ADA Compliance Program

Clark County Sheriff's Office Central Precinct – NE 149th Street

Date: March 6, 2008

Item # 4

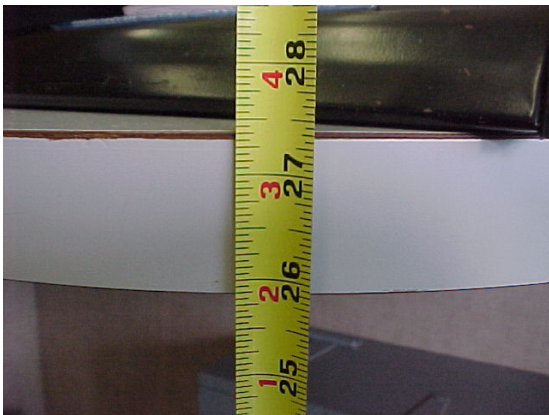
Issue: Access Aisle Lines

Location: South Parking Lot

Code: ANSI Chapter 5 – Section 502.4.4 Marking – Access aisles shall be marked so as to discourage parking in them.

Notes: Discourage Parking - Recommend re-painting the lines within the access aisles to discourage parking within the aisle area

Item # 5

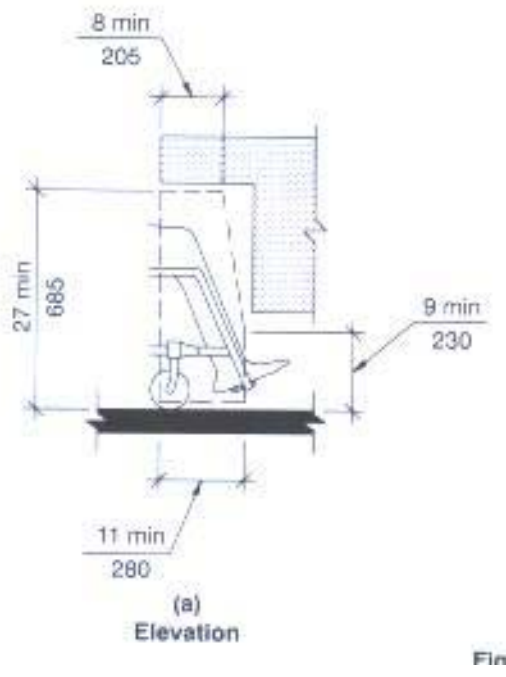
Issue: Height and Clearance

Location: Service/Work Counter in Lobby

Code: Code ANSI 306.3.3 Minimum Depth – Where knee clearance is required beneath an element as part of a clear floor space, the knee clearance shall be 11 inches minimum in depth and 9 inches above the floor and 8 inches minimum in depth at 27 inches above the floor.

Refer to drawing above.

1. Items under the service counter must be removed to provide wheelchair accessibility to the counter.
2. Display items on top of service counter must be removed when used by an individual for work.
